**SUBDIVISION &
ZONING AMENDMENT STAFF REPORT****Date: May 3, 2018****APPLICANT NAME**

KESCO Subdivision

Subdivision Approval to create a single legal lot of record from six legal lots of record; and Rezoning from B-2, Neighborhood Business District, to B-3, Community Business District, to allow the construction of a retail business with office and warehouse space.

SITE PLAN

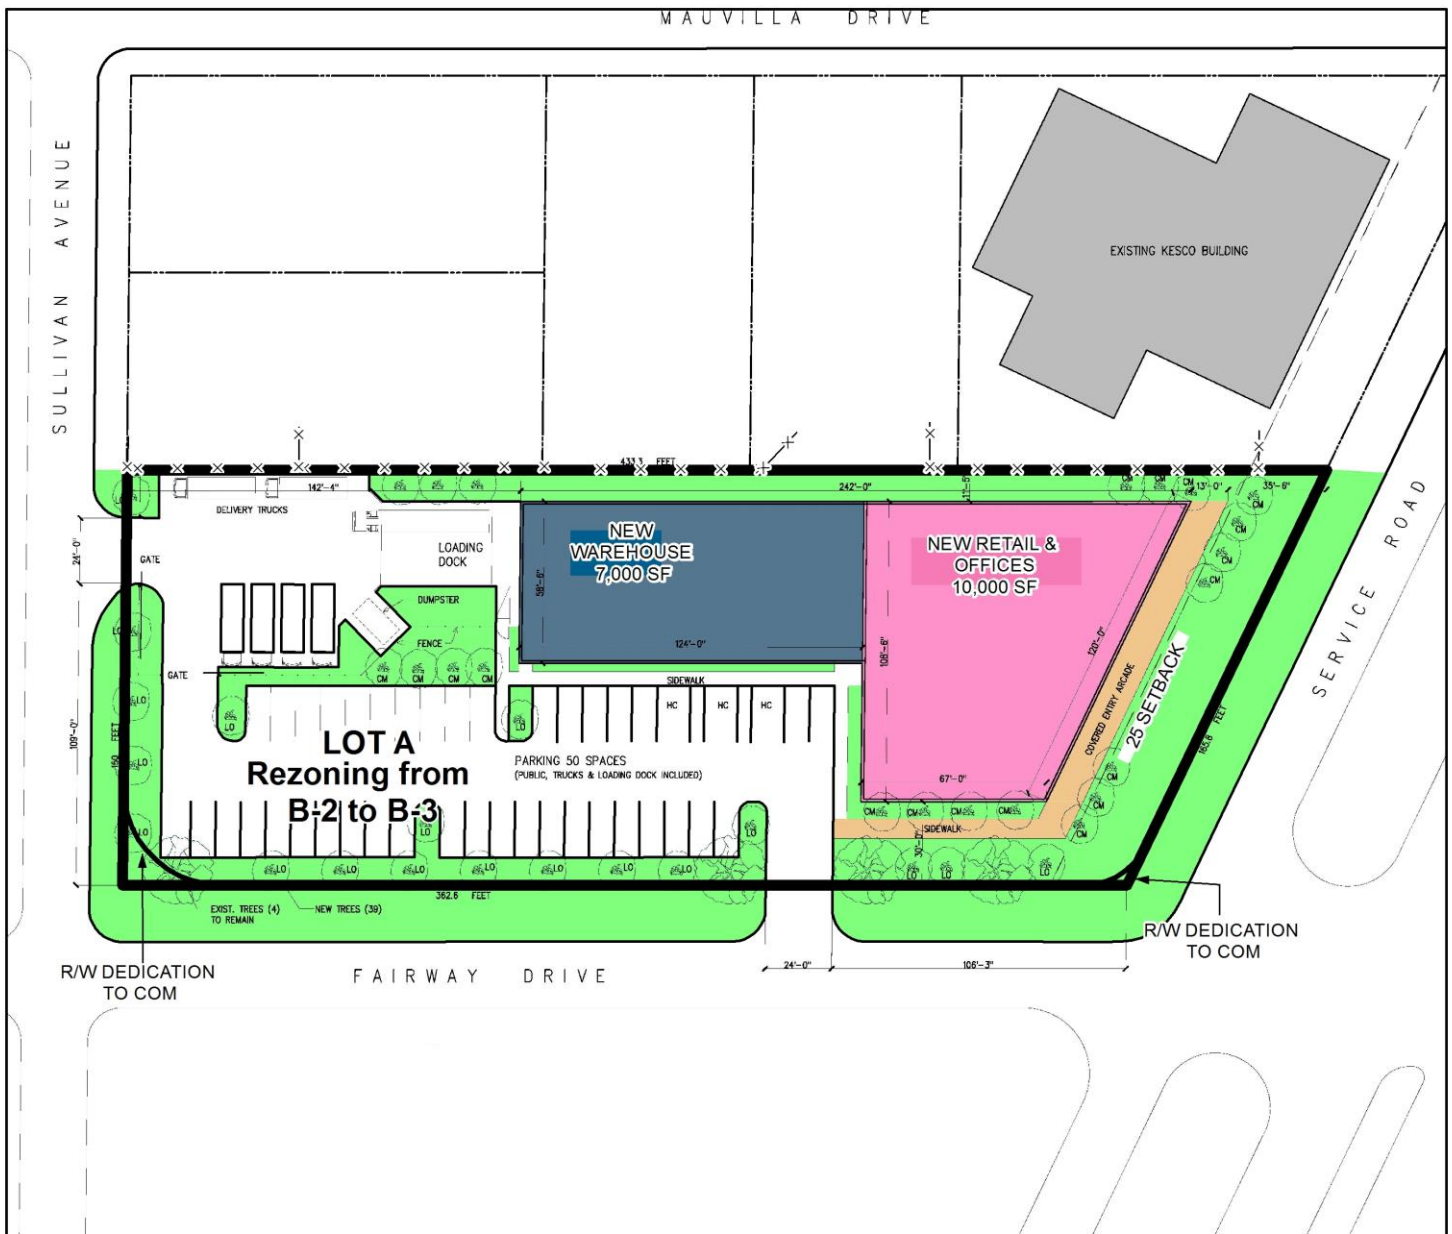
The preliminary plat does not illustrate the 25' minimum building setback along any frontage. If approved, this should be depicted on the Final Plat.

The applicant references the “Right Tree/Right Place”, however, it should be noted that no amendments have been made as of yet to the Zoning Ordinance to allow staff to consider alternatives to the current regulations. The site plan submitted depicts crepe myrtles along Government Boulevard, but these should be overstory frontage trees, under the current requirements.

The site plan has a note which states that 5 of the 50 parking spaces will be for warehouse employees, but there is no note that specifically states how many warehouse employees will be at the location. If approved, the site plan should be revised to include the number of warehouse employees.

The applicant discusses providing sidewalks where there currently are none, but the site plan submitted only depicts a sidewalk as part of a covered entry arcade along the front of the building, on private property. If approved, the applicant should be aware that sidewalks will be required to be placed along all street frontages, either in right-of-way, or on private property adjacent to the right-of-way along all frontages.

- 5) placement of a note on the Final Plat stating that the lot is denied direct access to the Government Boulevard Service Road;
- 6) illustrate the 25' minimum building setback line along all frontages;
